Minnesota Plumbing Board**Proposed Permanent Rules Adopting the 2018 Uniform Plumbing Code with Amendments****4714.0050 TITLE; INCORPORATION BY REFERENCE.**

TABLE 313.3.1

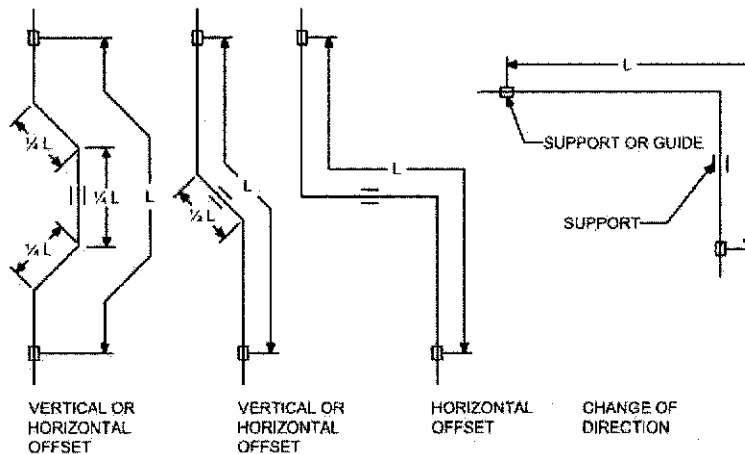
Subp. 2. **Section 313.** Table 313.3.1 is added to read as follows:

Schedule 40 PVC and ABS DWV and Storm Pipe Expansion Table

Inside the building thermal envelope

<u>Pipe Size</u>	<u>Length of Run (ft.)</u>		
	<u>10¹</u>	<u>20¹</u>	<u>30</u>
	<u>Expansion joint length (in.) = L</u>		
<u>1.5"</u>	<u>20</u>	<u>28</u>	<u>34</u>
<u>2"</u>	<u>22</u>	<u>31</u>	<u>38</u>
<u>3"</u>	<u>27</u>	<u>38</u>	<u>46</u>
<u>4"</u>	<u>30</u>	<u>43</u>	<u>52</u>
<u>6"</u>	<u>37</u>	<u>52</u>	<u>63</u>
<u>8"</u>	<u>42</u>	<u>59</u>	<u>72</u>
<u>10"</u>	<u>47</u>	<u>66</u>	<u>80</u>
<u>12"</u>	<u>51</u>	<u>72</u>	<u>88</u>

Outside the building thermal envelope

<u>Pipe Size</u>	<u>Length of Run (ft.)</u>		
	<u>10¹</u>	<u>20¹</u>	<u>30</u>
	<u>Expansion joint length (in.) = L</u>		
<u>1.5"</u>	<u>26</u>	<u>36</u>	<u>44</u>
<u>2"</u>	<u>29</u>	<u>41</u>	<u>50</u>
<u>3"</u>	<u>35</u>	<u>49</u>	<u>60</u>
<u>4"</u>	<u>40</u>	<u>56</u>	<u>68</u>
<u>6"</u>	<u>48</u>	<u>68</u>	<u>83</u>
<u>8"</u>	<u>55</u>	<u>77</u>	<u>94</u>
<u>10"</u>	<u>61</u>	<u>86</u>	<u>105</u>
<u>12"</u>	<u>66</u>	<u>94</u>	<u>114</u>

¹ Multiple offsets shall be allowed to provide expansion for each 30-foot developed length of run.
